Origination Form
Proposed Revisions to a Standard Plans Index

Originator:	Stepp, Richard	Index Number:	715-001
Date:	6/30/2026	Sheet Number(s):	1
E-mail:	richard.stepp@dot.state.fl.us	Index Title:	Conventional Lighting

Summary of the changes:

METAL POLE DETAIL

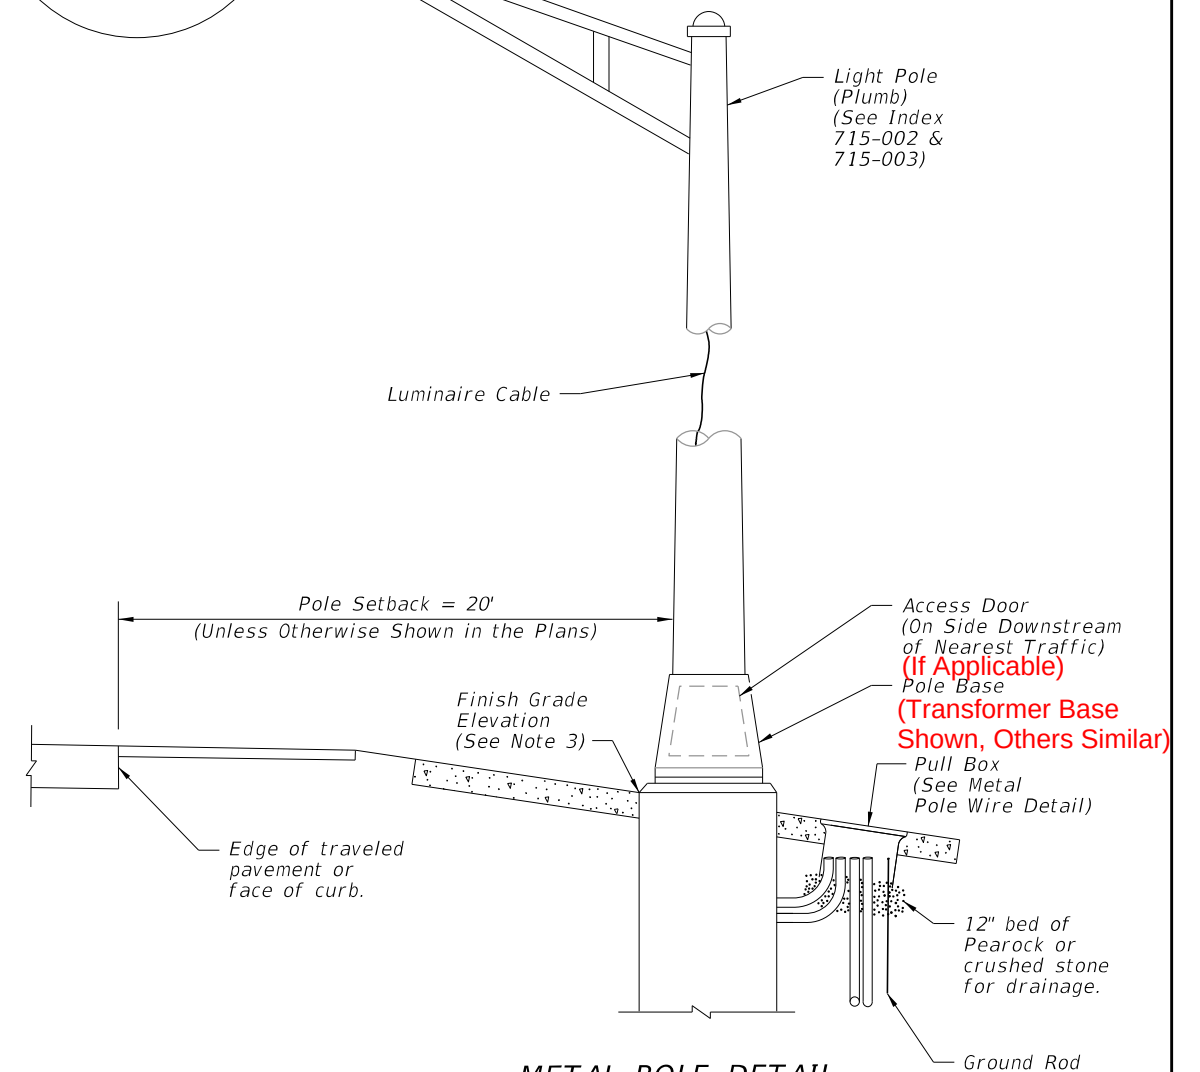
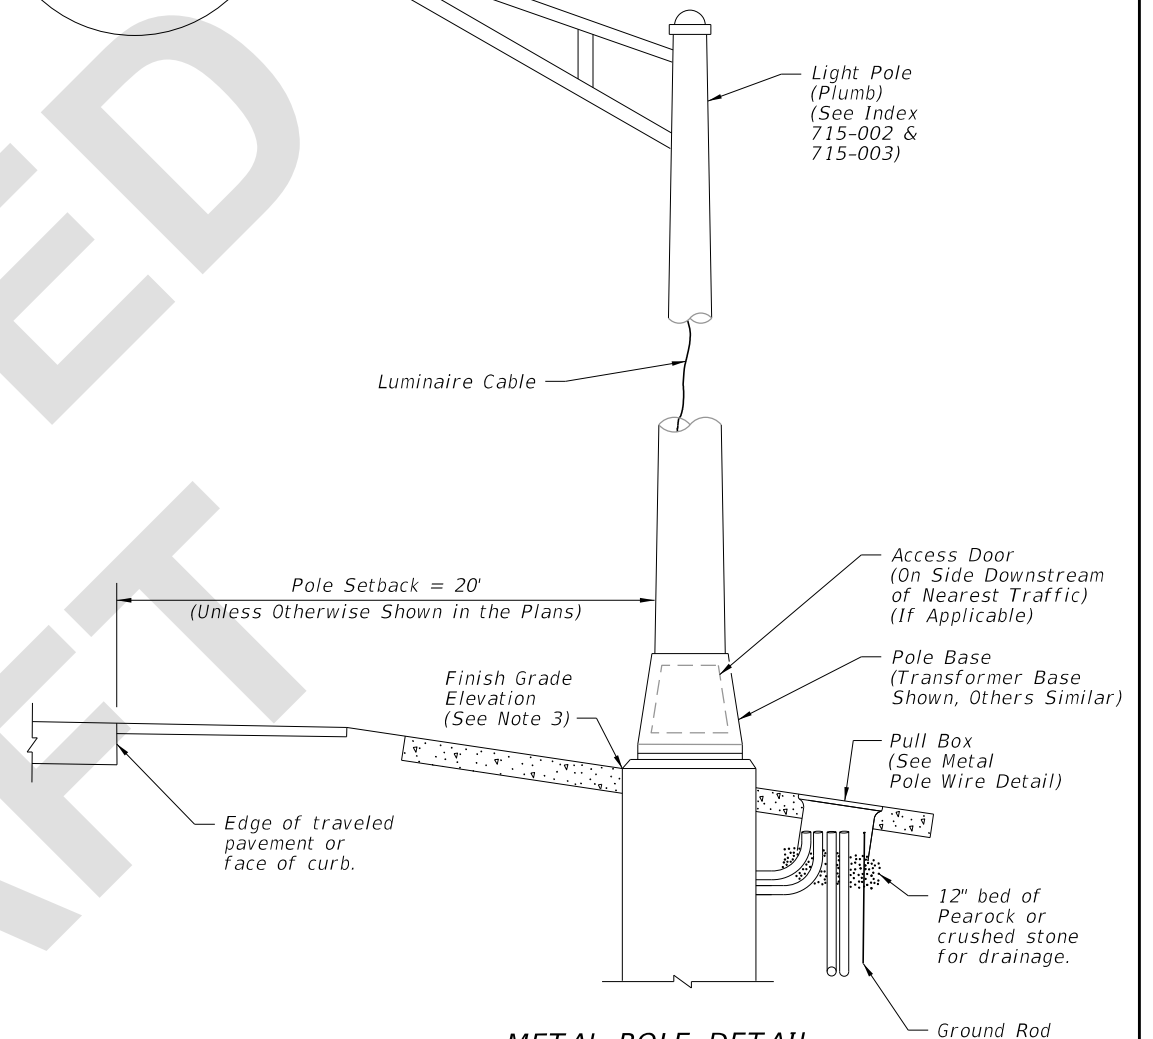
Sheet 1: Added "(Transformer Base Shown, Others Similar)" to the Pole Base callouts in the elevation details; Added "(If Applicable)" to the Access Door callout.

Revisions were made to support additional light pole base options as shown on the APL. For example, in addition to the transformer base option shown in the Index, the breakaway bolt option on the APL may be used instead. Having more light pole base options helps to alleviate supply chain restrictions, which may help improve construction schedules. Additionally, this revision helps to streamline the process by providing options that are pre-approved for BABA. This revision is being made in conjunction with others in Index 715-002, 715-003, and Standard Specifications 992.
